AR # 497

Petitioners' Comments on FutureGen's
UIC Draft Permits

Re: Comments on FutureGen's Underground Injection Control Draft Permit,
Morgan County Class VI UIC **Well 1, Permit No. IL-137-6A-0001**, dated
March 2014¹

Figure 1

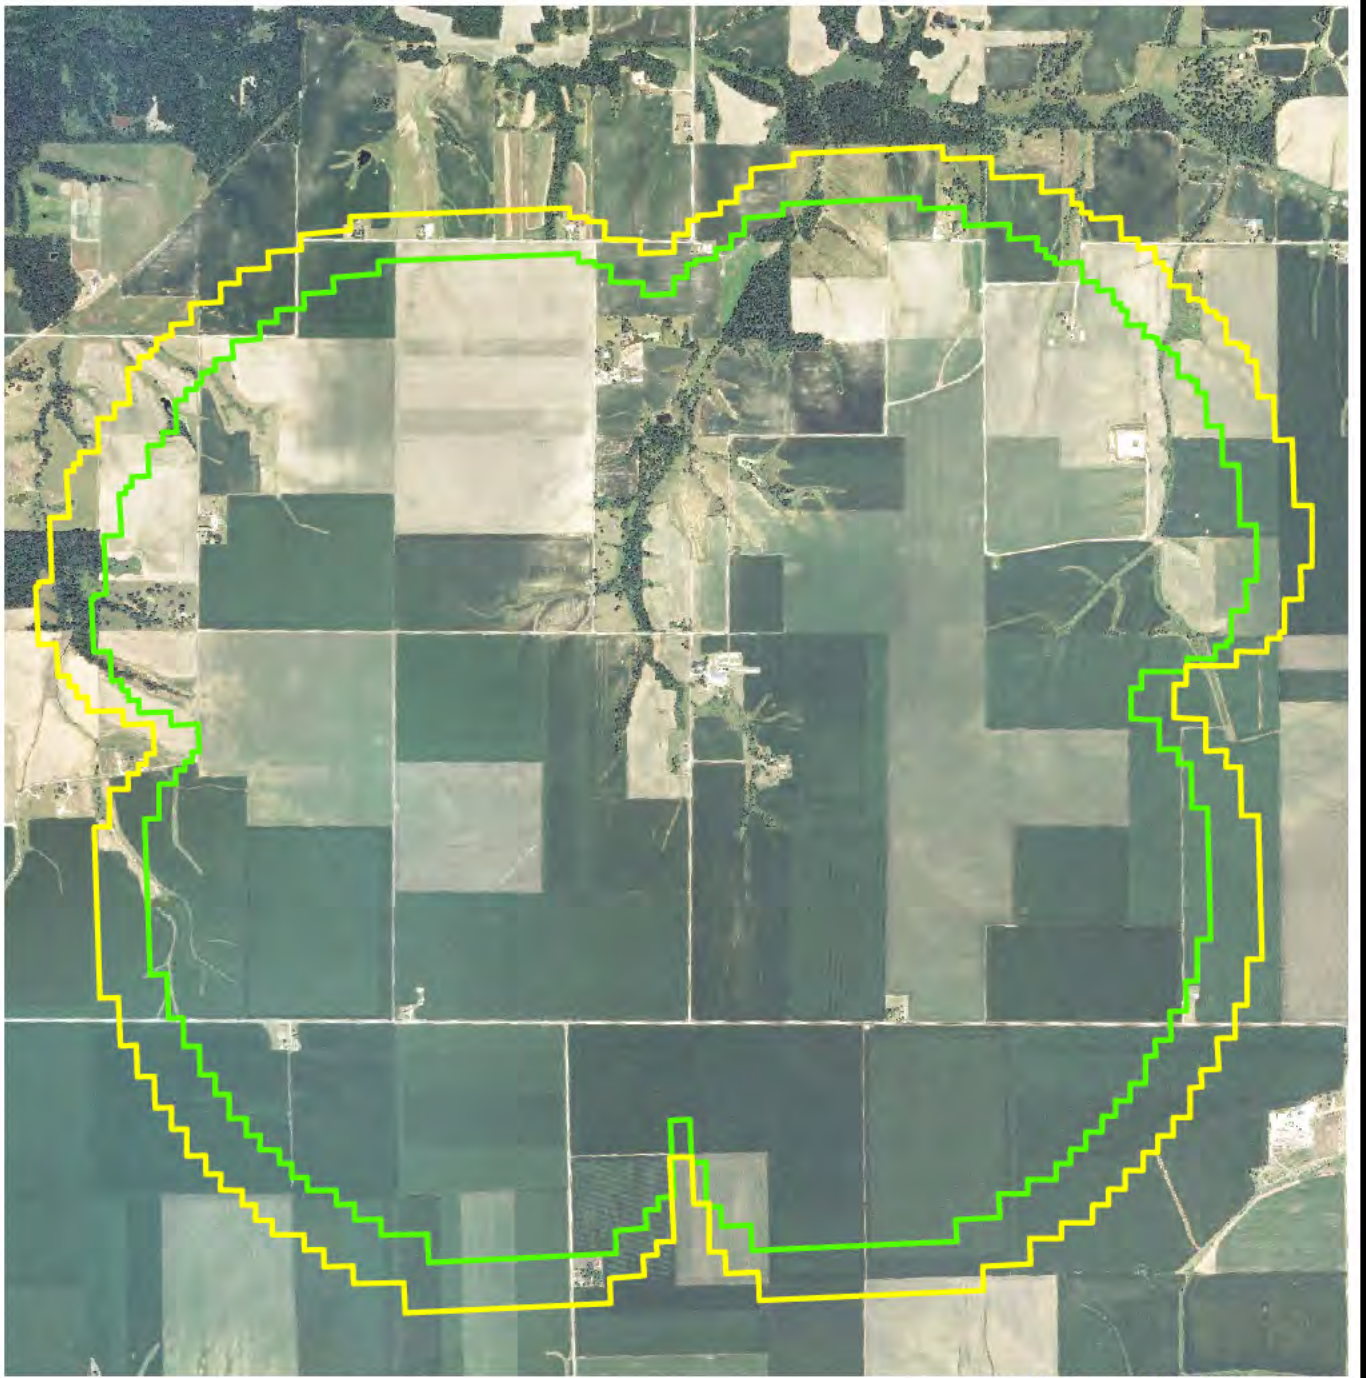
(Schnaar report). In fact, FutureGen's own modeling sensitivity analysis resulted in a plume 120% larger in size. See Ex. 2, para. 1 and Figure 1. Dr. Schnaar, in Figure 1 of his expert report, shows the impact of the 120% plume, and explains that the 120% size is a *minimum* size for the projected plume given the deficiencies of the model. *Id.* Further, the 120% minimum projected plume size does not account for the significant differences in injection rates and well construction amongst the injection wells. *Id.* at para 10. Thus, at an absolute minimum, the plume should be designated in the draft Permit as 120% larger than currently modeled.

FutureGen modeling and AoR delineation is not consistent with this EPA modeling guidance. Using “reasonable bounding values” for input parameters, FutureGen’s existing modeling sensitivity analysis resulted in a plume as much as 120 percent larger in size than their base case model runs (FutureGen, 2013, p.3-42, 3-43). I have included a map (Figure 1) with the FutureGen estimated supercritical CO₂ plume, and a plume area 120 percent larger. The 120-percent larger plume is likely a *minimum* for how much larger the FutureGen projected CO₂ plume should be given limitations in FutureGen’s sensitivity analysis, and other FutureGen modeling limitations as discussed below. It is essential for FutureGen to provide a conservative estimate of the extent of the supercritical CO₂ plume in order to effectively manage project risk and design the site monitoring network.
